Final Subsequent Environmental Impact Report
Ravenswood/Four Corners Transit Oriented Development Specific Plan Update

SCH#: 2022040352

November 2024

FIGURE 2.3-6

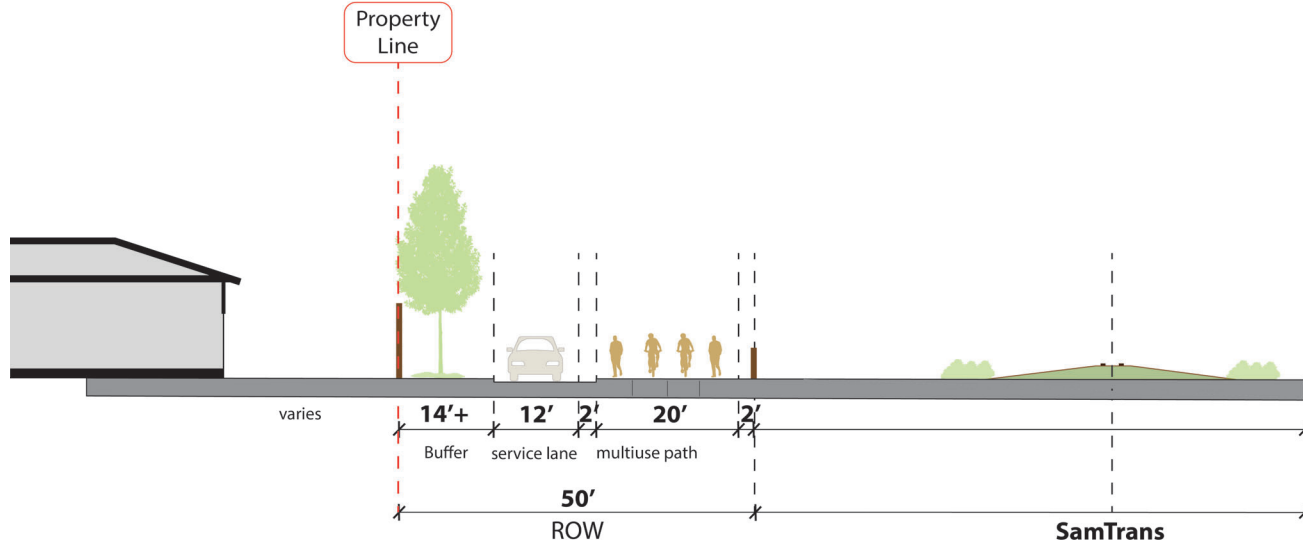
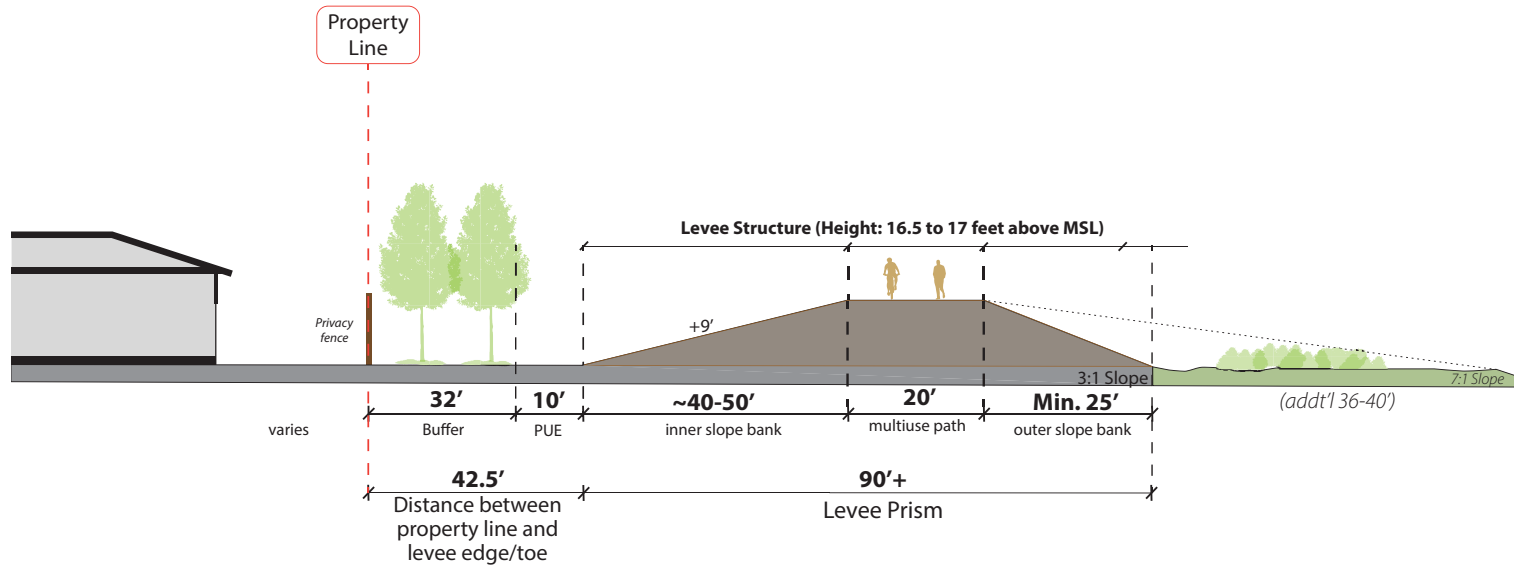
6. Figure 2.3-6 Multi Use Path Cross Sections - (page 22) - The PUE easement as proposed by the SFCJPA as diagramed in the lower drawing is 22 feet - not 10 feet.

Response U.10: This comment pertains to the width of an easement, and does not concern the Draft SEIR's analysis of the Specific Plan Update's buildout. The commenter is correct. The section for the SFCJPA will be updated to reflect the correct buffer width. See Section 5.0 Text Revisions for the updated Figure 2.3-6 on Draft SEIR Page22.

REPLACE Figure 2.3-6 Multi-use Path Cross Sections without Loop Road with the following figure which includes the correction to the buffer width between the property line and levee at the eastern perimeter of the Plan area:

FIGURE 3.2-2

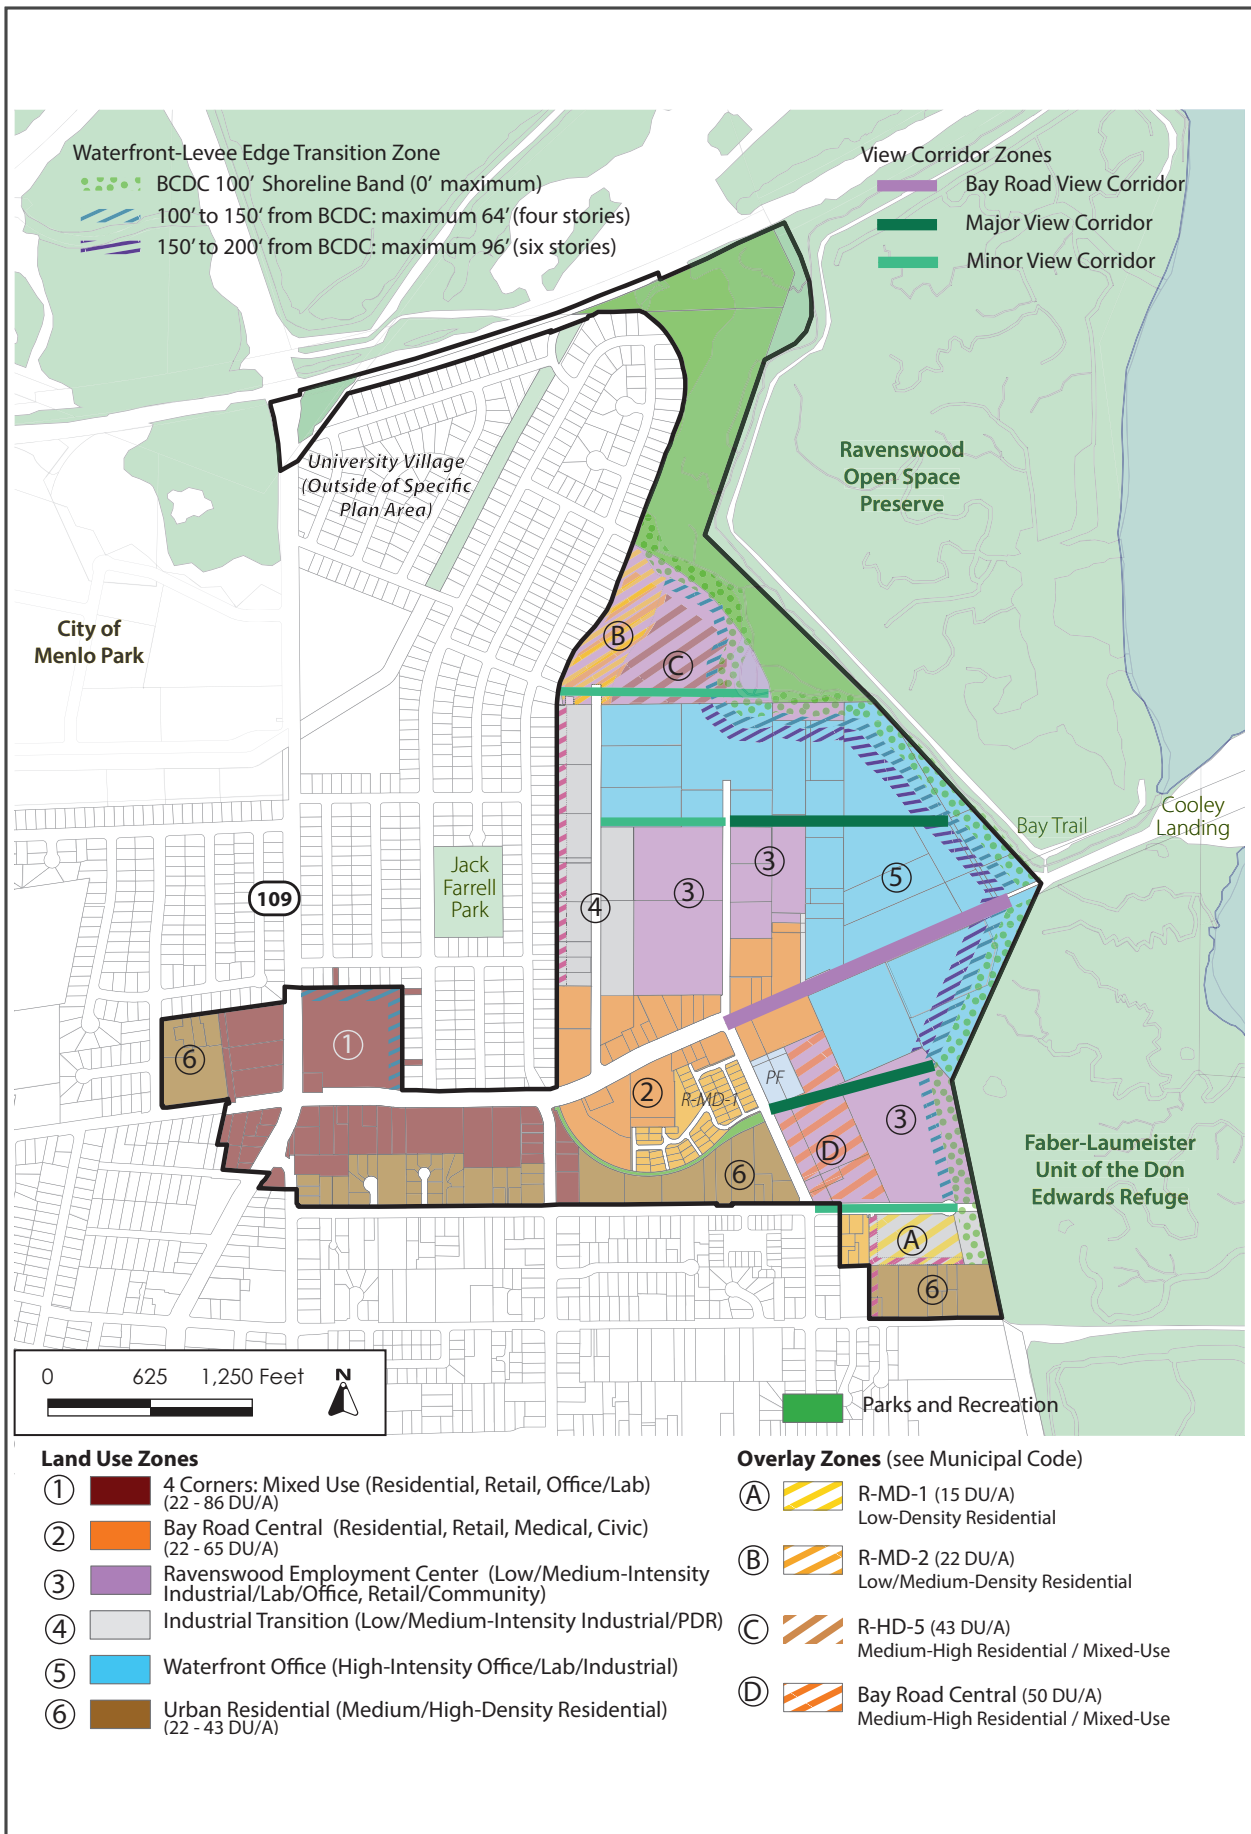
However, the SEIR does not provide any viewshed analysis of the proposed buildings' heights and bulk along the waterfront-levee edge transition zone, which will be closest to Ravenswood Preserve. Photos 1 through 16 from pages 38-45 show existing conditions but not the development scenarios. For example, viewshed analyses should be conducted and provided for public review for these two transition zones to evaluate the visual impacts along the Ravenswood Bay Trail corridor north of Bay Road:

Page 50 **REVISE** Figure 3.2-2 Stepback Locations and View Corridors to show an overlay of the transition zones, future land uses, and the Bay Trail:

Page 214: **ADD** Figure 3.9-1a Properties with Land Use Covenants after Figure 3.9-1 Properties with LUST Cases and Cleanup Program Sites:

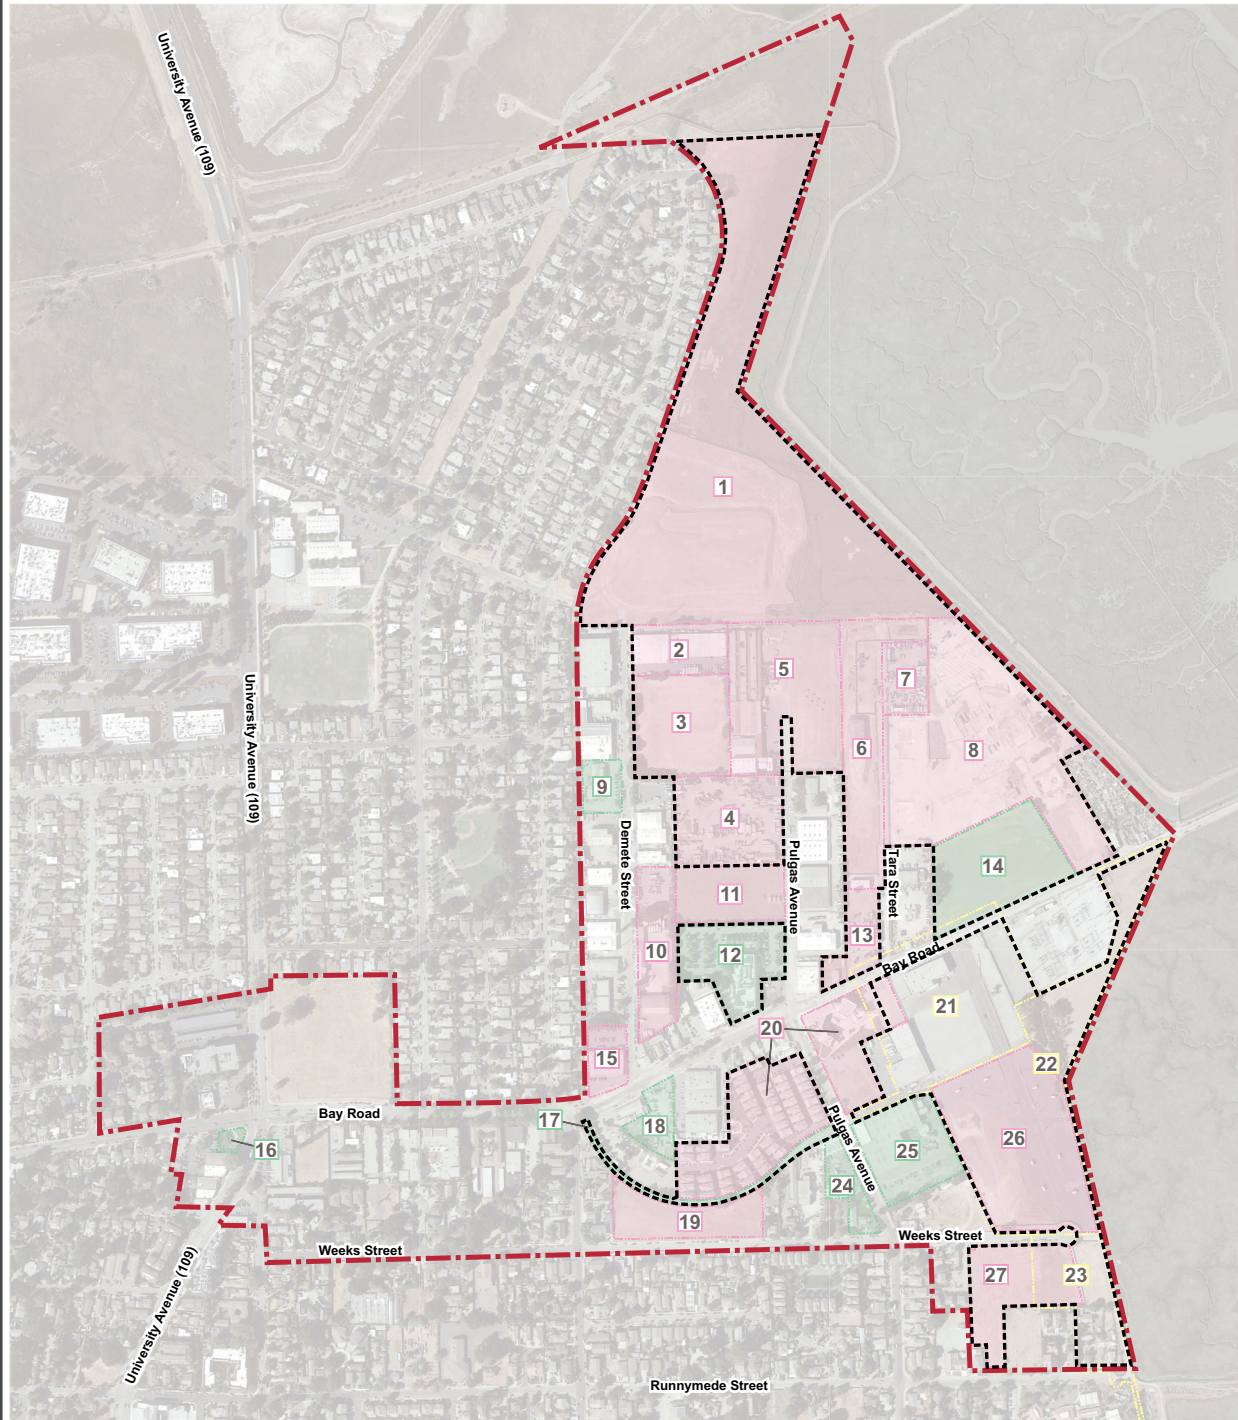
- Table 3.9-1 regarding Historical Uses and Reported Spills sites should be clarified to identify that several of the listed sites have been fully assessed and remain "open" only due to land use covenants directing the measures required to the development of the property. We recommend that Figure 3.9-1 be revised to depict properties that have been fully assessed, have recorded a land use covenant, and an approved risk management plan. Further, Section 3.9.1.2, Ravenswood Industrial Area, p. 215, should be updated to include the following information, which we recommend adding to paragraph 2, following sentence 2:

Response K.20: Draft SEIR Figure 3.9-1 (Page 214) is intended to show the reported open and closed leaking underground storage tank (LUST) and cleanup program site (CPS) cases in the Specific Plan area, as of the time when the SEIR was prepared. It is acknowledged that the conditions on sites within the Plan area and their regulatory status may change over time. Figure 3.9-1a (which is Figure 3 in the Appendix D Screening Level Environmental Site Assessment), which shows the properties with land use covenants (deed restrictions) in the Specific Plan area, has been added after Figure 3.9-1 (refer to Section 5.0 Draft SEIR Text Revisions). Each property on the above figures is labeled with a number (which is also shown in Draft SEIR Table 3.9-1, Page 213). Draft SEIR Table 3.9-1 provides information available about the

Page 238: **REPLACE** Figure 3.10-2 Tsunami Hazard Area with the following figure which references California Geological Survey as the map source:

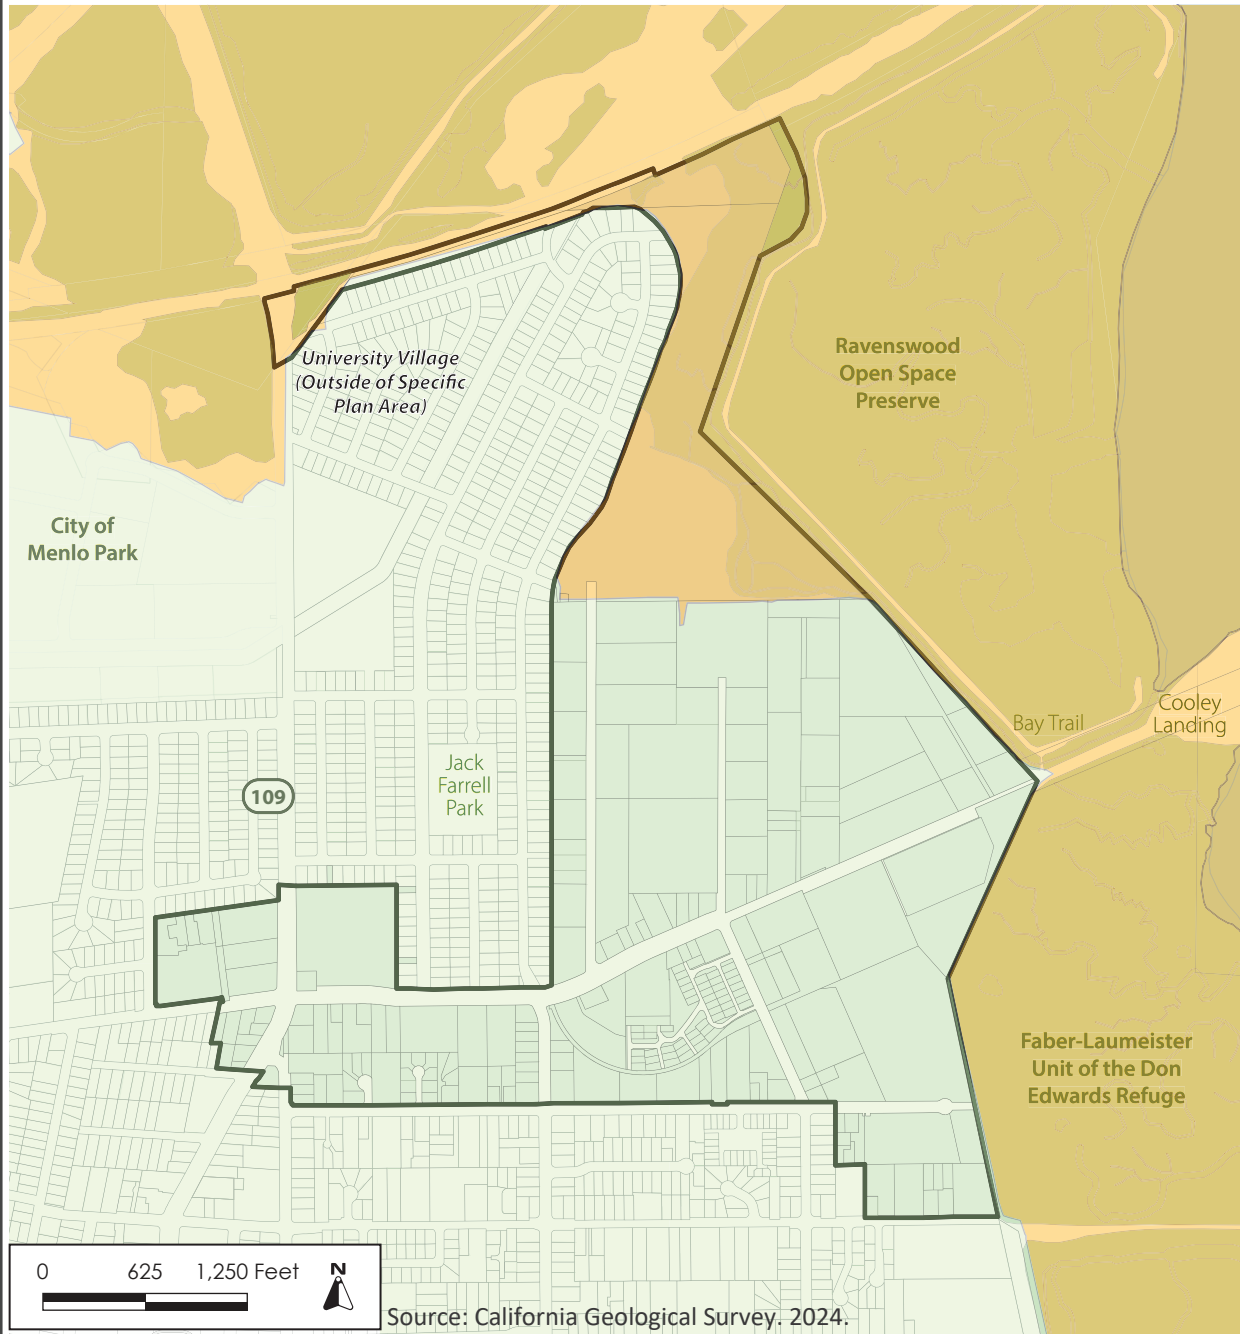
7. Figure 3.10-2 (page 238). Tsunami Hazard Zone - I'm not clear how this map was established but it seems arbitrary and maybe not inaccurate.

Response U.11: As shown on Draft SEIR Page 238, Figure 3.10-2, the source of the Tsunami Hazard Area within and adjacent to the Specific Plan area is shown as the U.S. Geological Survey. Figure 3.10-2 has been updated to reference the California Geological Survey (which shows the same Tsunami Hazard Area identified on Figure 3.10-2 of the Draft SEIR). The reference to the U.S. Geological Survey is a typographical error. Refer to Section 5.0 Draft SEIR Text Revisions of this Final SEIR.
